RE: New Information in Relation to PCF 1617 - Tiered Code Requirements

# Does Tier 5 Represent Net Zero Energy Ready?

Tier 5 Envelope Target  
and Net Zero Energy Ready Homes

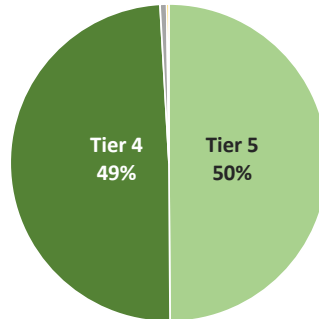
*The proposed Tier 5 envelope target reflects only half of net zero energy ready homes built*

The proposed tier 5 envelope target aligned with about 50% of Net Zero Ready homes. The tier 4 target was in alignment with 99% of Net Zero Ready homes.

This shows that the envelope target for tier 5 is much more stringent than necessary to achieve net zero energy ready levels of performance.

## What We Found: Envelope

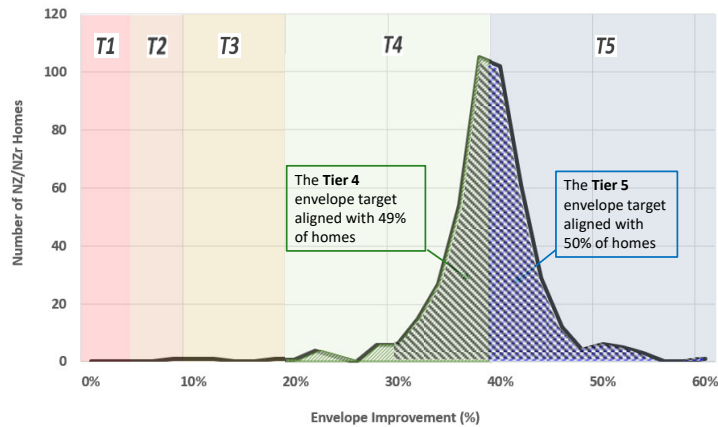
The tier 4 target is in closer alignment with most net zero energy ready labelled homes than the tier 5 target.

A tier 5 envelope target of 30% would align with 96% of the CHBA net zero homes (see the black shaded area).

Tier 5 Energy Target and Net Zero Energy Ready Homes

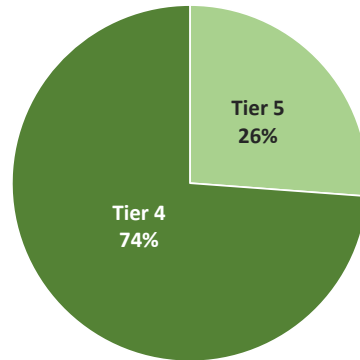
*74% of CHBA-labelled homes perform at NZr level below what is proposed at tier 5 target*

The proposed energy target for tier 5 is in alignment with only 26% of the homes built that achieve net zero energy ready performance. Net zero energy ready homes are achieving net zero ready performance levels with less stringent requirements than those proposed for tier 5.

## What We Found: Energy

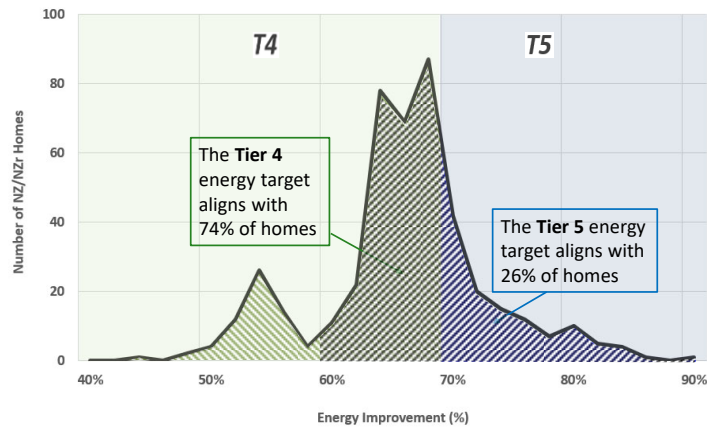
This chart shows that the tier 4 energy target is in closer alignment with net zero energy ready homes—all of the Net Zero homes in this study met or exceeded the tier 4 energy target.

The **peak cooling** target and Net Zero Energy Ready Homes

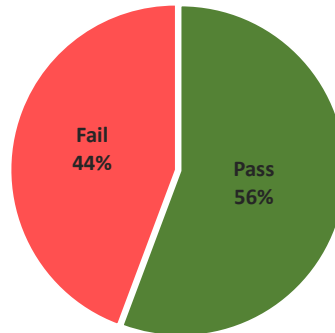
*The peak cooling target reflects only 56% of NZr homes*

As currently proposed, to meet any tier, the peak cooling load for the proposed house must not be greater than the peak cooling load for the code reference house. This criterion does not consider actual energy efficiency, or protection from overheating.

The study shows that the proposed tier 5 criterion only reflected 56% of the CHBA-labelled homes. This shows that the proposed pass/fail cooling load criterion is not appropriate to evaluate net zero energy ready performance.

## What We Found: Cooling

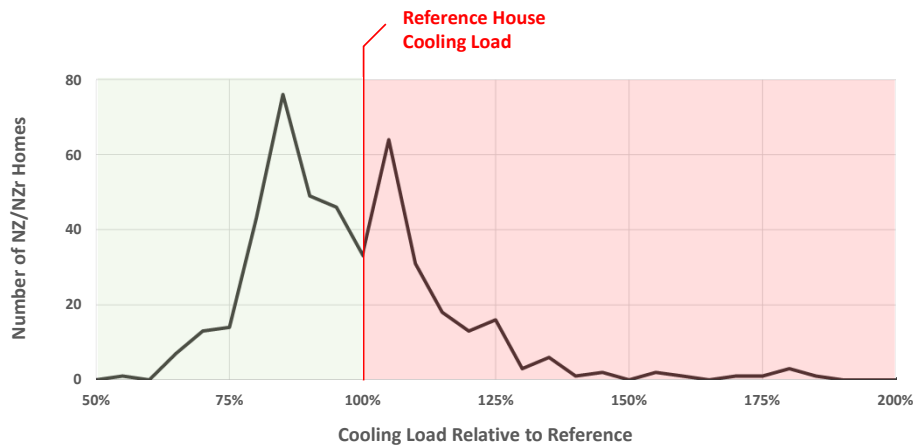
This graph shows peak cooling load as a percentage of the reference house peak cooling load. The tiers align with the homes to the left of the red line on the green background as these homes have a lower cooling load than the reference house. The criterion did not align with the homes to the right of the red line on the pink background.

## Overheating

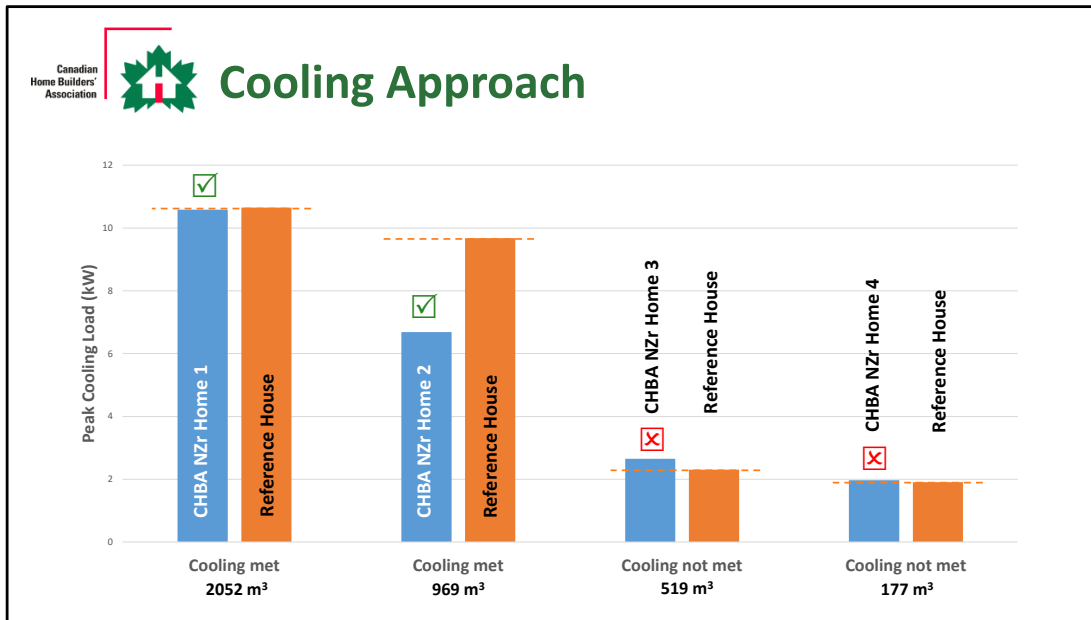
There is one aspect of the cooling requirement that may not be obvious. These four sets of data represent four homes in the Net Zero data set. Proposed cooling criteria are in line with the two homes on the left that have relatively high cooling loads (in blue) since the homes have lower cooling loads than the reference house load (in orange). The cooling criterion is not in line with the two homes on the right which have relatively low cooling loads—since the reference cooling load is even lower.

The criterion would have accommodated Home 2 even if it had a much higher cooling load—almost as high as Home 1, which is twice as big. With an adjustment to the window to wall ratio or the solar heat gain coefficient, Home 4 may have been able to meet the cooling load, but that may not be the case for Home 3 which has a bigger difference. Home 3 is also more than twice the size of home 4 but has only a slightly higher cooling limit.

This shows that the proposed peak cooling criterion is counterproductive where the goal is energy efficiency. The proposed cooling criteria appears arbitrary and unrelated to energy efficiency.
